# High-bandwidth Digital Content Protection System

## Interface Independent Adaptation

Revision 2.~~2~~1

~~18 July, 2011~~20 August, 2012

**Figure 2.3.  $E_{k_h}(k_m)$  Computation**

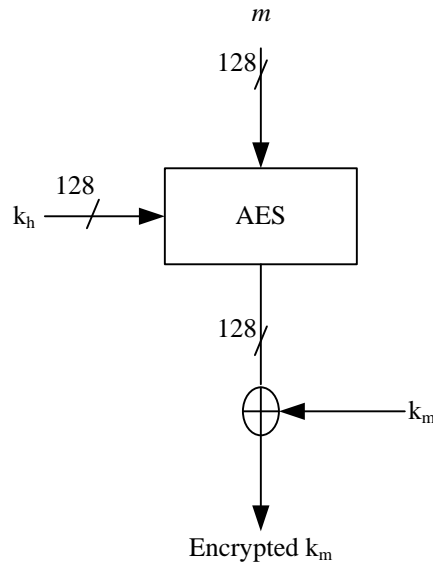
128-bit  $m$  is constructed by ~~appending 64 0s to~~ concatenating  ~~$r_{tx}$  with  $r_{rx}$  ( $r_{tx} || r_{rx}$ ).~~ Both values are in big-endian order. The HDCP Receiver may persistently store  $r_{tx}$ ,  $r_{rx}$  and corresponding  $E_{k_h}(k_m)$  values when it implements pairing with an HDCP 2.0-compliant Transmitter or when  $AKE\_Transmitter\_Info.VERSION = 0x01$ .

**Figure 3.2. HDCP Cipher Structure**

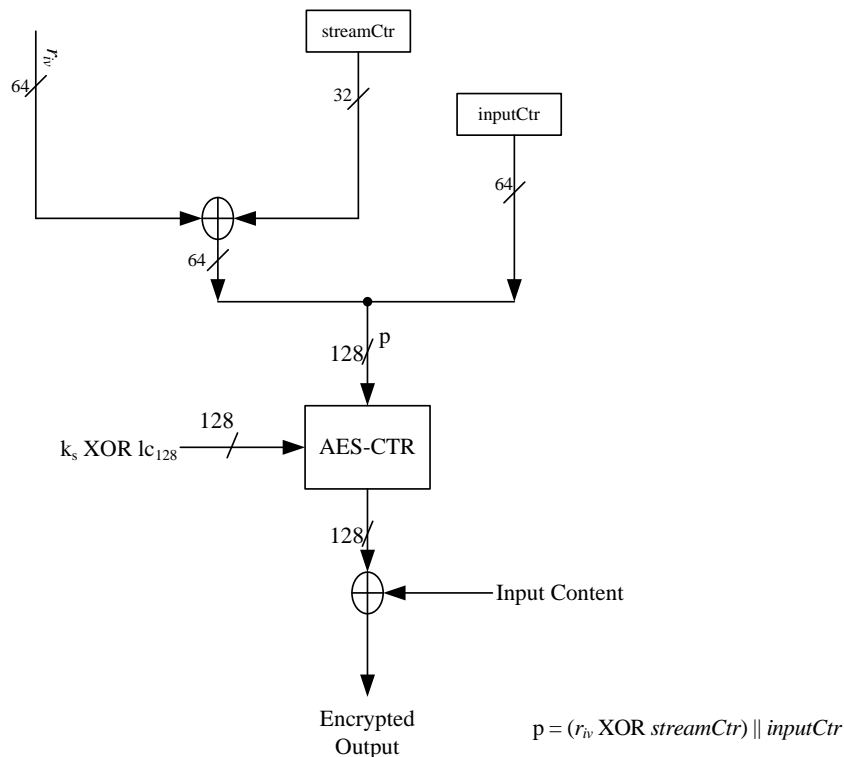
$k_s$  is the 128-bit Session Key which is XORed with  $lc_{128}$ . ~~All eE~~ elementary streams within a given program or across multiple programs use the same  $k_s$  and  $r_{iv}$ .
